Analysis of the Stream Restoration Design of Donaldson Run Tributary B in Arlington, VA

December 2020

Figure 6. A portion of Drawing C-1 (VHB, 2019) showing proposed uniform meanders. Right and left bank are based on a downstream view with flow from left to right. The area highlighted by the red box is discussed in text.

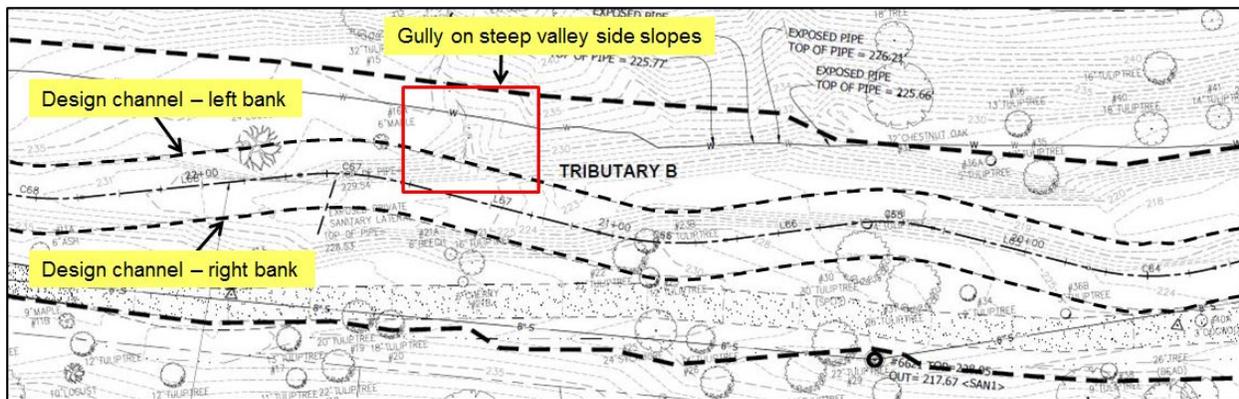
Implementing the design channel as presented in VHB (2019) will necessitate a massive and costly earth-moving operation that will result in a significant realignment and alteration of the current channel and adjacent portions of the valley bottom. Numerous uniformly shaped meanders will be constructed in the upper portion of Tributary B (Figure 6). The justification for this is based on the fact that “alluvial” streams (those streams that are capable of self-forming a channel across a floodplain) tend to form meanders to achieve an equilibrium condition. However, as stated above, Tributary B never had a floodplain and was never able to self-form a channel prior to urbanization. As a consequence, the design channel does not truly represent the natural stable configuration for this setting and, as a consequence, instabilities will likely result.

The red box in Figure 6 highlights one of many locations where the design channel approaches the steep valley side slopes due to the lateral space needed to create the proposed meandering planform. At the highlighted location, a steep gully on the side slope will drain directly into the proposed channel and, as a result, could rapidly deposit large amounts of sediment. Such rapid inputs of sediment are unlikely along alluvial rivers that flow across a low floodplain, so the design (that essentially assumes Tributary B is alluvial) does not plan for such “outside” inputs of sediment and the proposed channel will be destabilized as a result.

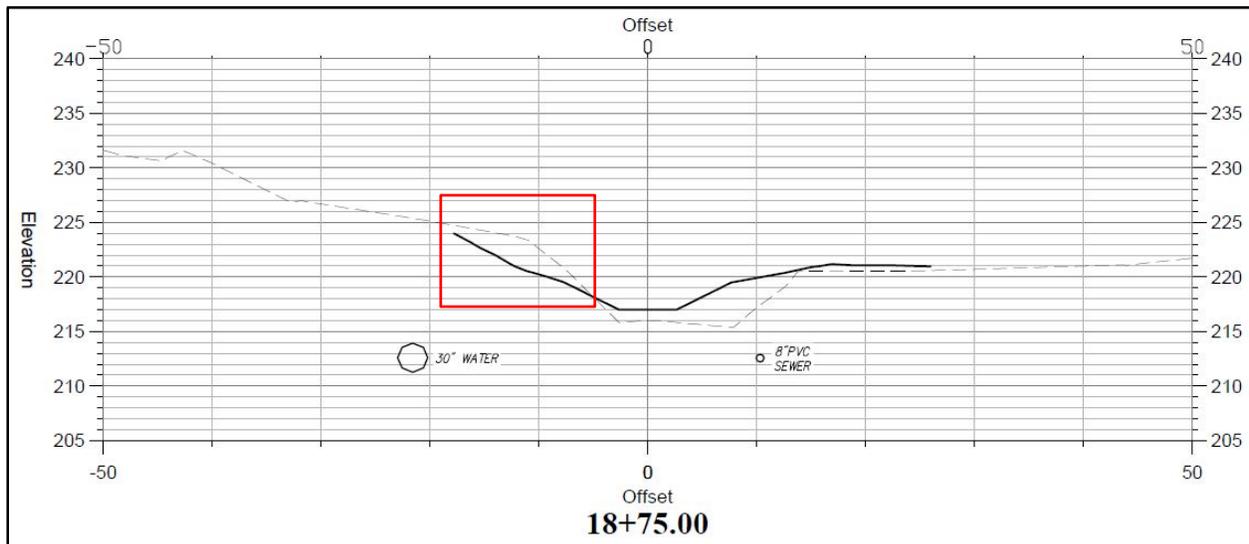
Figure 7 is a cross section showing one location where the design channel will actually be excavated into the base of the steep valley side slope. This could destabilize the slope and trigger a landslide – a threat that will increase over time as flow in the design channel continues to impinge on and eat away at the slope. No evidence is provided in the design package (VHB, 2019) that documents a geotechnical analysis has been completed to determine the risk of such a landslide. The potential consequences of a landslide (or rapid inputs of sediment from the gully highlighted in Figure 6) would be to completely infill the design channel, allowing the flow to escape the design channel, reform a new channel elsewhere on the valley bottom, and cause the abandonment of the entire design channel downstream. This begs the question “Why does the design propose to form meanders in the upper confined section of Tributary B where no meanders ever existed before?” and also demonstrates that the primary project objective to stabilize the stream will not be achieved.

Figure 8. The lower sinuosity design channel proposes to cutoff the existing high sinuosity meander (centerline shown with dashed red line). (From VHB, 2019, Drawing C-2)

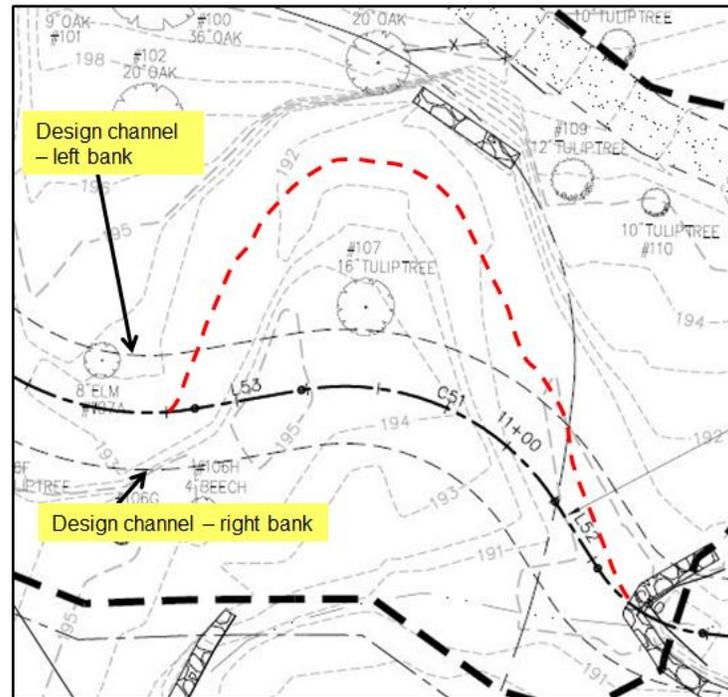
By maintaining essentially the same uniform meander shape throughout the project, problems at the downstream unconfined end of the project are also possible. The proposed design will cutoff one of the existing highly sinuous meanders (Figure 8) that, as described in Section 3.0 above, is the natural stable meander form for this setting. The proposed less sinuous meander, then, will be an unstable feature that will eventually be undone over time as the more sinuous meander

dimension is reestablished. This process would most likely be initiated when backwatering caused by high water in Tributary A leads to deposition and infilling of the design channel.

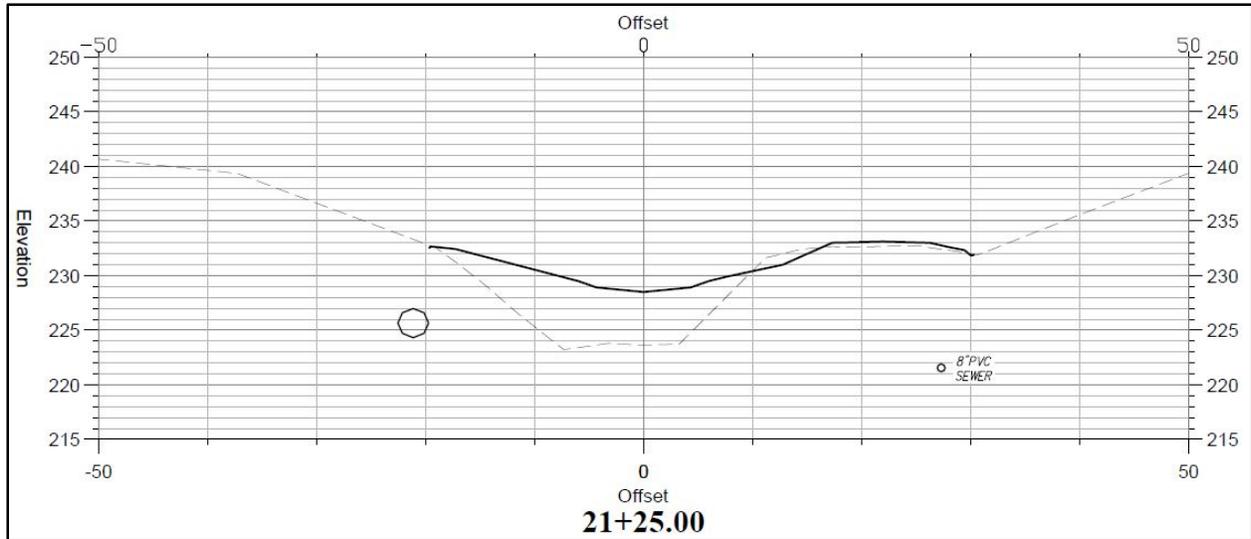
VHB's (2019) restoration design proposes to fill, at least partially, the existing incised channel with what will presumably be a mixture of sand, silt, and clay (Figure 9). The amount of fill to be added is generally greater in the upper part of the proposed project with much less needed downstream where the existing stream is less incised. However, some fill is proposed for nearly the entire project's length. The cross section in Figure 9 is typical for the upper portion of the project with the depth of fill ranging from 5 to 7 feet depending on the position of the "thalweg" (i.e., deepest portion) and banks of the proposed channel. No details are provided in the design plans regarding the total volume, character, or origin of the fill to be used. The design justification for filling the existing channel with more than a thousand cubic yards of presumably imported fill is twofold: 1) to elevate the stream bed so that flows can more easily escape the channel and spread over the flat valley bottom in order to limit the stream power exerted in the design channel; and 2) to narrow the channel to approximate the expected width of an equilibrium channel in an undisturbed setting (with an adjustment factor added in recognition of urbanization as described in VHB, 2019, Drawing D-1).

Figure 10. Cross section showing particularly well how fill placed in existing channel (dashed line) will create a narrower design channel (solid line) through most of the project’s length. (From VHB, 2019, Drawing C-12)

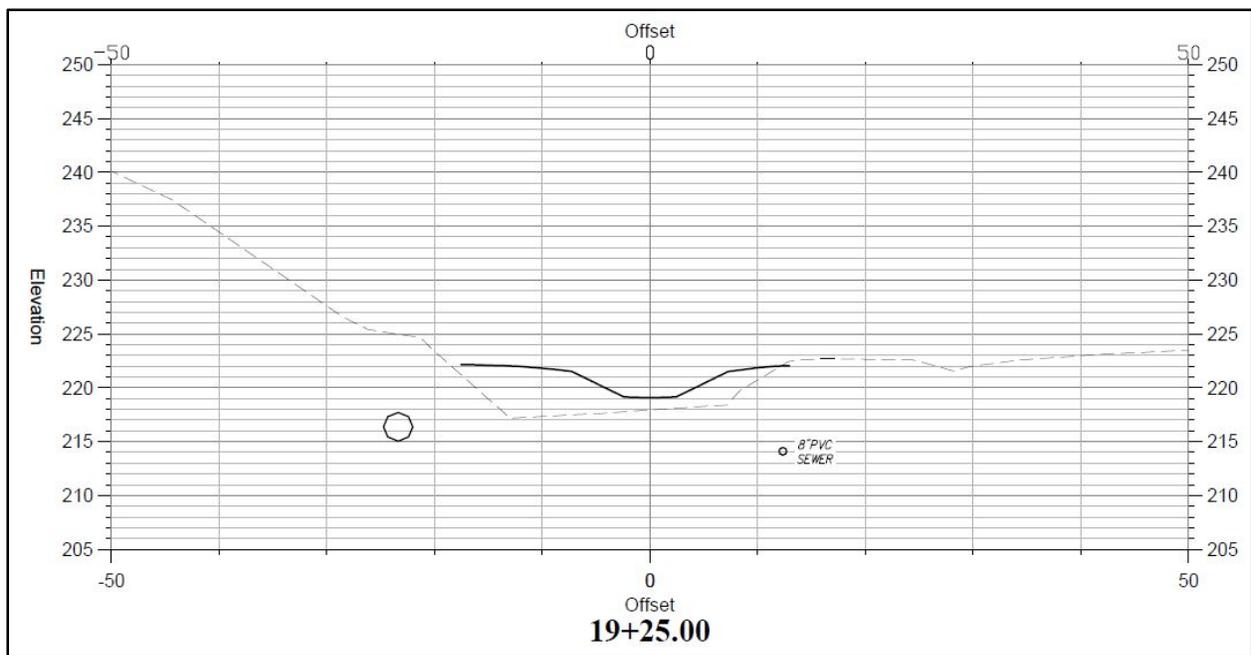
Elevating the stream bed by adding fill in the channel increases the stream’s gradient and, in turn, increases the stream’s capacity to carry sediment. The stream’s length in the project area is being shortened from 1,404 feet to 1,331 feet (VHB, 2019, Drawing C-3) due to planform changes like that shown in Figure 8, leading to additional slope increases. (Perhaps imperceptible to the human eye, streams trending towards an equilibrium condition are sensitive to even minor slope changes.) The fill is also being added to the existing channel to narrow its width (Figure 10). Squeezing the flow through a narrower channel, like putting a finger over the end of a garden hose, will further increase the flow’s velocity and ability to carry sediment.

What may appear as only subtle changes resulting from adding fill to the existing channel could actually cause significant problems. Please note that elevating the stream bottom and narrowing the channel by adding fill stands in stark contrast to the stream's natural channel response of incision and widening that has been ongoing for several decades. As described above in Section 3.0, this has been occurring to achieve a new equilibrium condition in balance with the urbanized watershed. Why, then, is the sediment that has taken decades to wash downstream now being replaced with imported fill? The long-term fate of the fill will invariably be similar to previous soils eroded away given that implementation of the project will have no effect on the high volume of runoff emanating from the urbanized watershed. Simply changing the form (i.e., width, slope, and sinuosity) of the channel as proposed in the restoration design does not change the process at the root of the problem.

Figure 11. Cross section showing existing channel (dashed line) filled in to accommodate design channel (solid line), but leaving a low spot on the valley bottom (highlighted by red arrow) beyond the limit of disturbance. (From VHB, 2019, Drawing C-11)

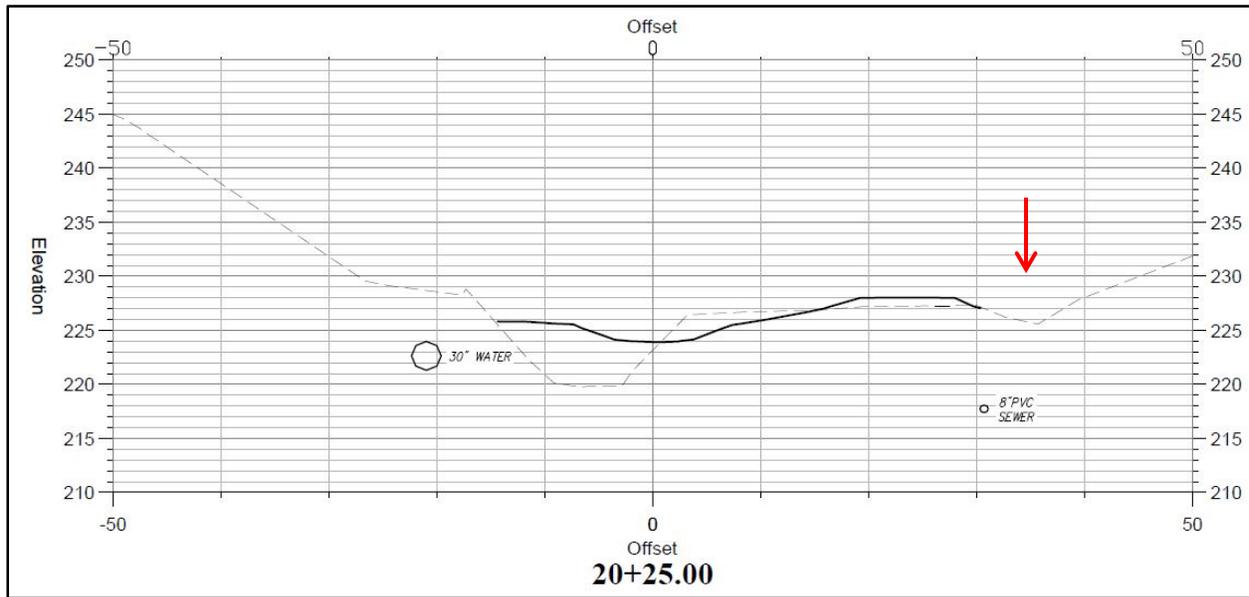
The increased flooding of the valley bottom surface could have even more serious consequences as well. Where the design channel extends beyond the limits of the existing channel, the existing channel will be filled to the level of the valley bottom, but existing low spots on the valley bottom beyond the limits of disturbance will remain (such as the drainage swale along the walking path) (Figure 11). These low spots near the downstream end of the project are at times even lower than the bottom of the design channel itself (see VHB, 2019, Drawing C-16, Section 11+25.00).

The overbank flow emanating from the design channel will preferentially concentrate in these low spots on the valley bottom and could initiate channel incision to a depth lower than the design channel itself. In such an event, the design channel would be abandoned and the entire flow of the stream diverted to the newly incised channel. The potential damages from a new channel being carved on the valley bottom are significant as most of the existing low spots on the valley bottom are immediately adjacent to the sewer line. While the likelihood of such an event is low, dismissing a low risk event would be unwise given the potential high cost of repairs. By adding fill in the existing channel but leaving low spots on the valley bottom, the project could fail to meet its primary objective of stabilizing the stream and the project's explicit goal to protect adjacent infrastructure.

Figure 12. Portion of typical cross section showing 18-inch rock bed layer to be added to design channel along the length of the restoration project (From VHB, 2019, Drawing C-6)

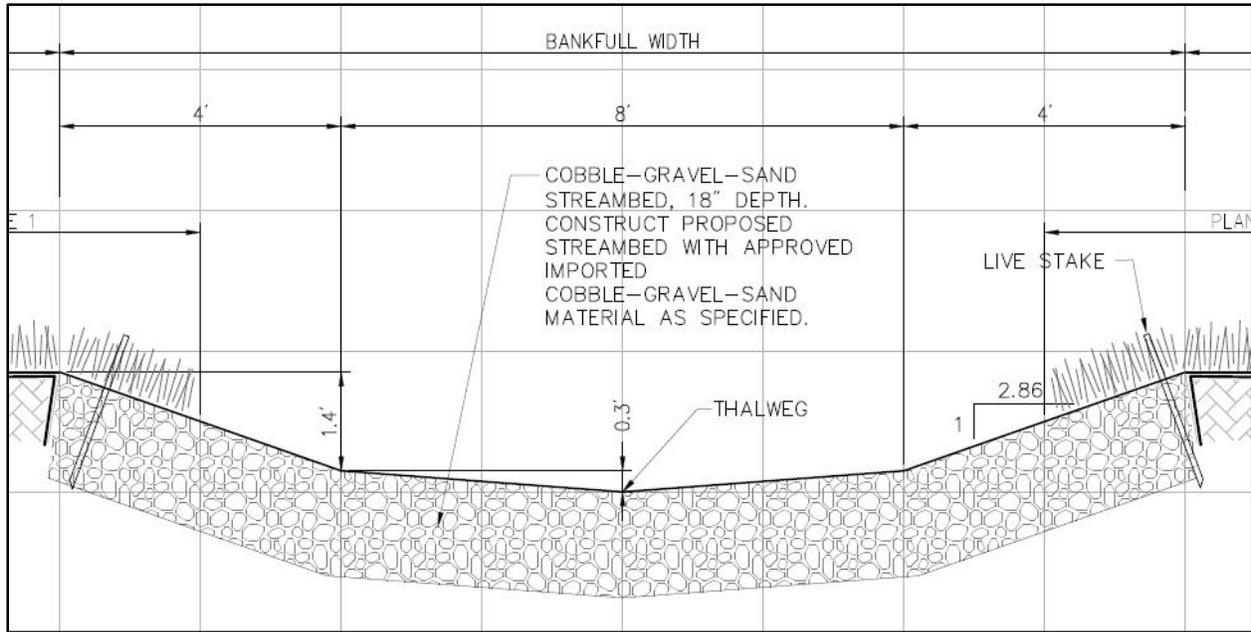
Large rock is to be placed in the design channel in the form of an 18-inch thick bed layer across the entire channel bottom (and banks) throughout the length of the project (Figure 12). The “ D_{84} ” rock size to be used will have a diameter of 15 inches (i.e., a small boulder), which means that 84 percent of the rock will be smaller (including at least 10 percent sand) and 16 percent larger than that value (VHB, 2019, Drawing D-1). Much larger more rectangular boulders (with an intermediate axis diameter up to 5 feet) will be used to build a variety of step-like rock structures (VHB, 2019, Drawing C-4 and C-5) throughout the project's length (Figure 13). The justification for the coarse bed layer is to keep the stream bed and banks from eroding given that the sediment supply from the urbanized watershed is lower than in a more natural environment. The numerous boulder step structures are justified as “grade controls” (i.e., to prevent downcutting of the channel) and habitat features.

The rock size used in the 18-inch thick bed layer has been carefully selected to remain immobile up to a 10-year flood event (VHB, 2019, Drawing D-1). What will happen, however, during an even larger flood when the bed layer is able to move? With only finer-grained fill underneath the coarse bed layer (see Section 4.2 above), the implication, perhaps expectation, is that the design channel could be enlarged through bed and bank erosion with the currently existing gully

Figure 12. Portion of design plan showing several of the boulder step structures to be built across the proposed channel along its entire length. (From VHB, 2019, Drawing C-7)

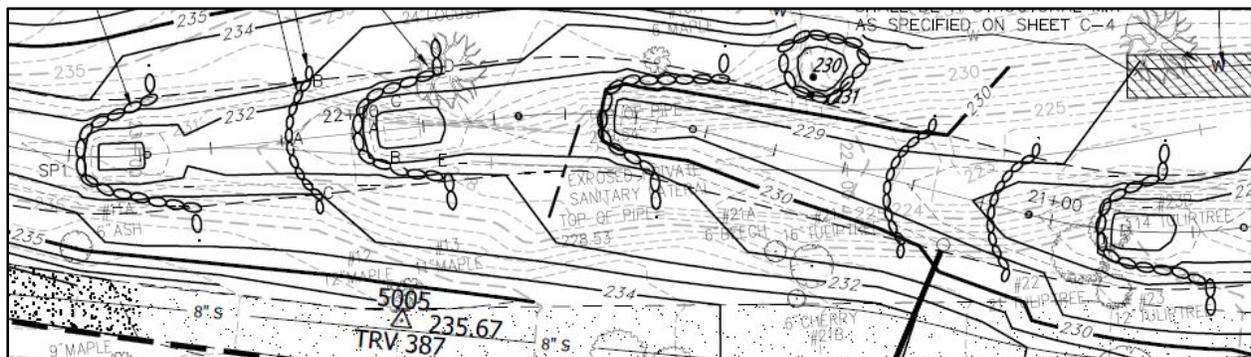
The large rock, although not explicitly stated, is essentially being used to armor or lock the proposed design channel in place in direct contradiction to the basic tenets of Natural Channel Design (Rosgen, 2011). As a result, the use of large rock in the design is a tacit acknowledgement that the proposed project cannot function as a geomorphically “stable” channel (see Section 2.0 above). By creating a static rather than a stable channel with the freedom to adjust its position over time, several potential problems are likely to arise if the project is implemented as designed.

The use of the large boulders to form the rock step structures also presents problems. Boulder steps are natural features found on confined and steep mountain streams. While the upper portion of the restoration reach on Donaldson Run Tributary B is confined and fairly steep, the soils are largely composed of fine-grained material with no boulders occurring naturally. When stream flows encounter a contact between large immobile boulders and fine erodible sediment, the stream will preferentially and aggressively scour the fine sediments on the bed or banks of the channel. Since the boulder steps will be set below the coarse bed layer (VHB, 2019, Drawing C-5), undermining of the structures seems less likely than the “outflanking” of the structures (i.e., lateral erosion around the steps) due to bank erosion. Similar outflanking of boulder structures occurred as a result of bank erosion along the design channel constructed as part of the nearby Donaldson Run Tributary A restoration completed in 2006 (Figure 13).
